Heritage KMR.CDD.MIQ.1916-1918.01(A)
2004 of 1918.

With reference to the Bank at
Karachi India under construction, Messrs: Cox & Co: are informed it is observed that they are deviating from the approved plan as regards arrangement of some of the rooms, stairs, doors and windows.

Re Cox's new building

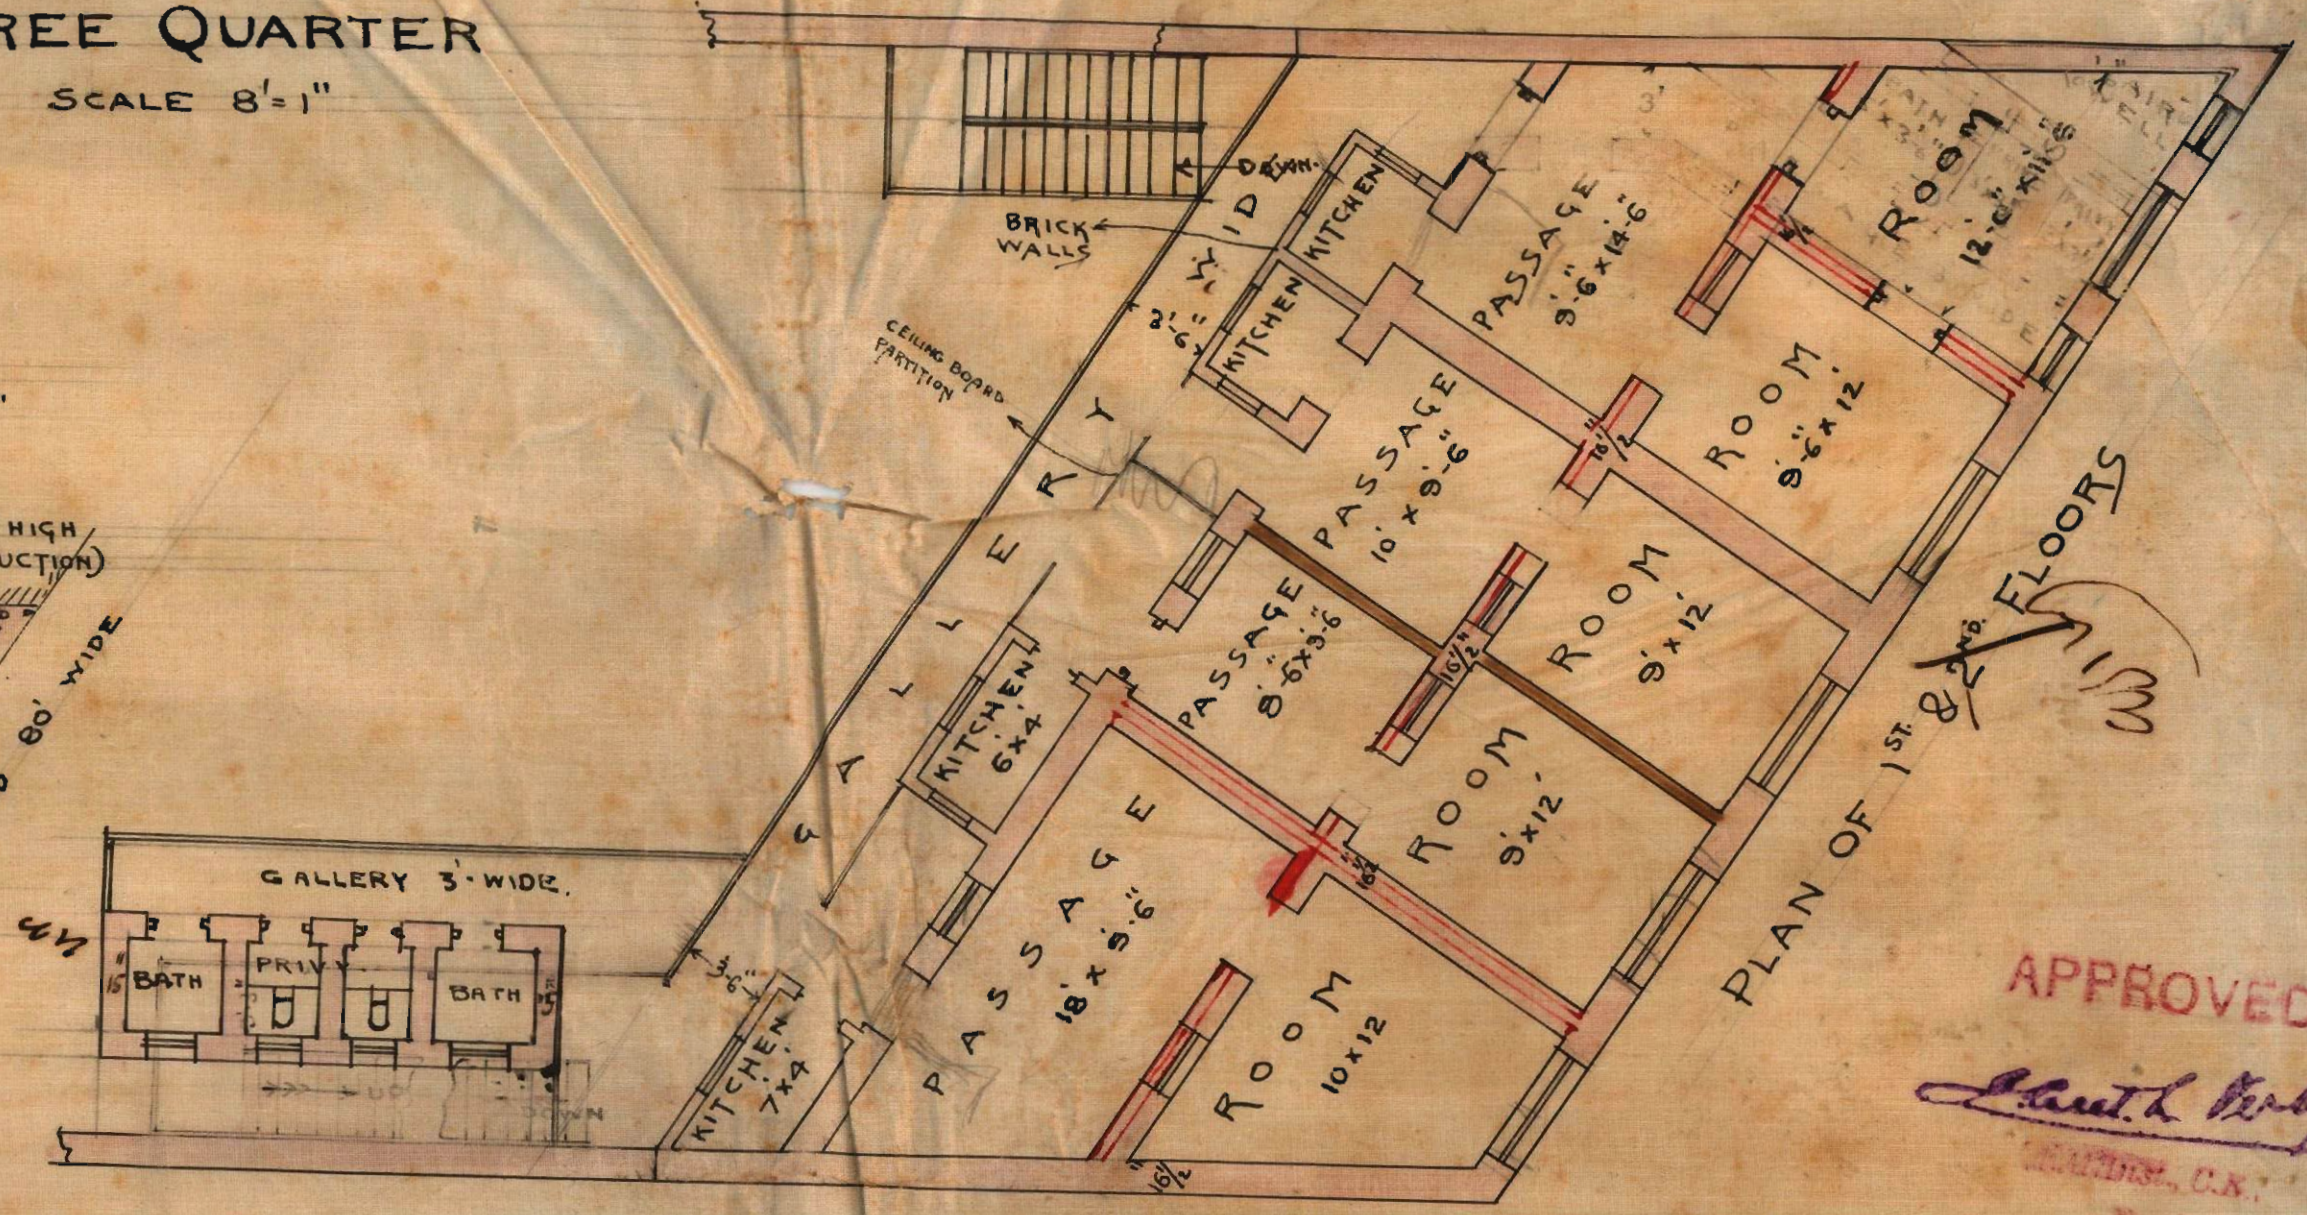
Inform owner that not more than $\frac{1}{2}$
 of the area of the plot will be allowed
 to be built on.

only one building will be allowed
 on a plot of less than 2000 sq. ft.
 in this gr.

All buildings must be set back
 at least 10'-0" from the
 compound walls.

It must be shown on the plan
 how he proposes to connect
 w.c. with the drainage system.
